**REPORT FOR
High Vista Estates Subdivision
Ansonia, Connecticut**

Environmental Review Team Report

Ansonia Inland Wetlands Commission

JULY 1988

**PROPOSED
SUBDIVISION
EAST SIDE**

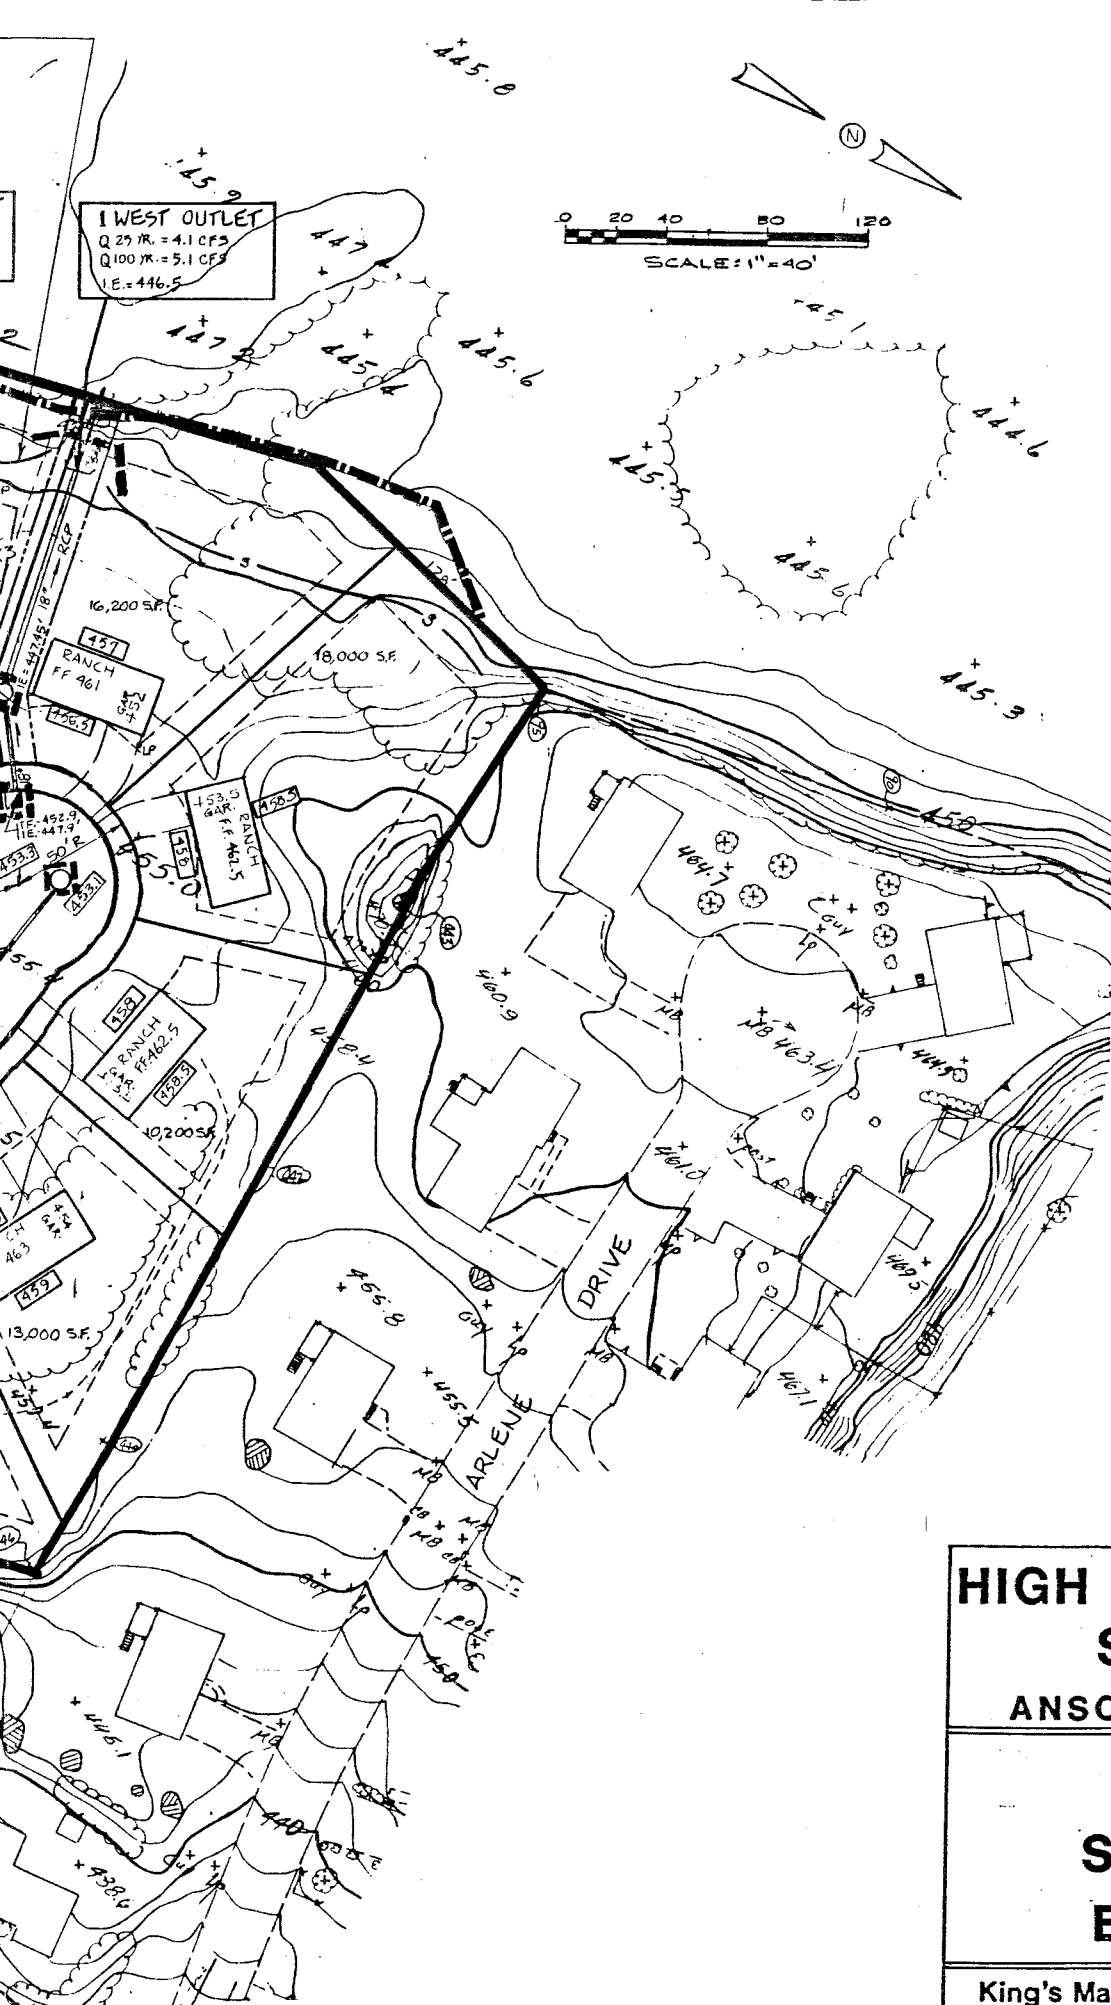
- 3) Silt fences should be installed at least 6 feet from the toe of slope (natural or fill).
- 4) Additional stabilization of the steep slopes on the back of proposed Lots 17, 18, 19 and 20 may be needed.

- 5) Construction pads are needed for entrances onto Mountain View Drive and Benz Street.
- 6) The silt fence should be extended on Lot 26.
- 7) Details on grading, stabilizing and outletting the swale between Lots 25 and 26 are needed.

**PROPOSED
SUBDIVISION
WEST SIDE**

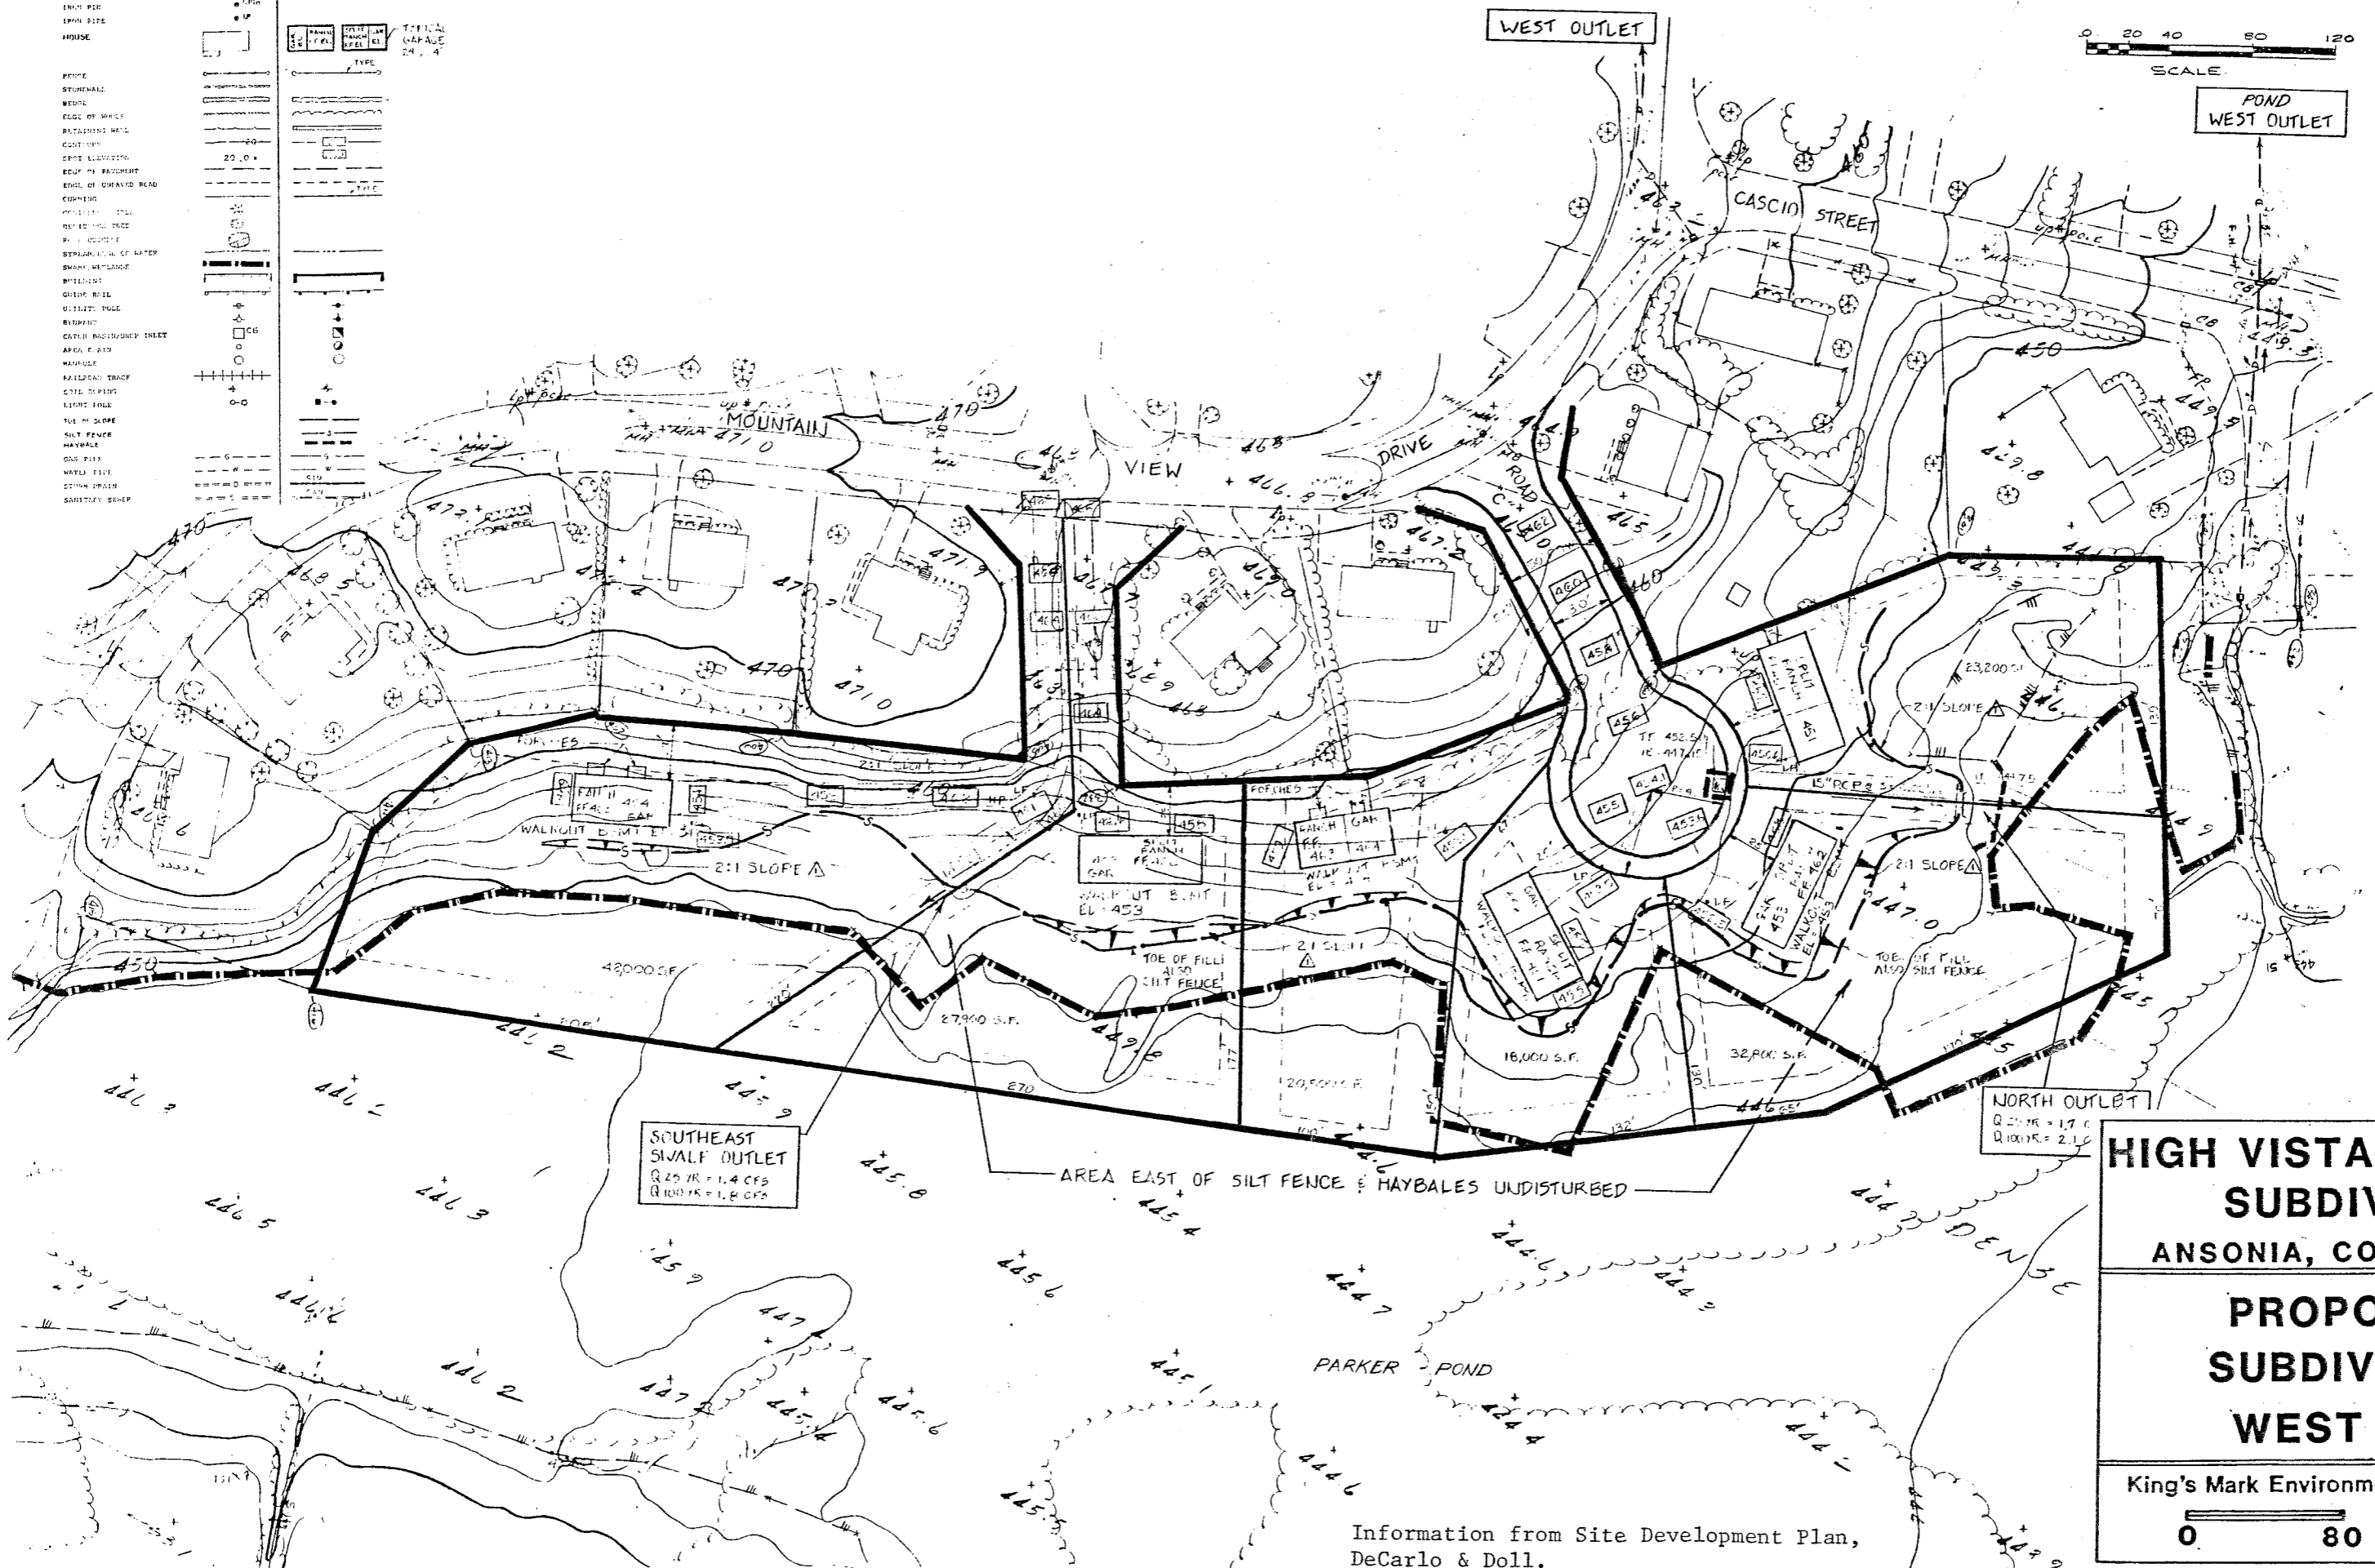
- 1) The lots on the western side of Parker Pond are narrow with a very limited area of non-wetland available for the construction of homes, driveways and yards. The "limits of construction" as shown may not be realistic. To prevent contractor error, clearing and/or wetland limits should be clearly marked in field with flagging or barriers.

- 2) A number of lots (especially on the western side) show 2:1 fill slopes. Areas of 2:1 slopes are not "usable yard space," are difficult for the homeowner to maintain and are difficult to stabilize initially. Slopes of 3:1 to 5:1 are more desirable. Homeowners with usable yards are less likely to encroach on wetlands.
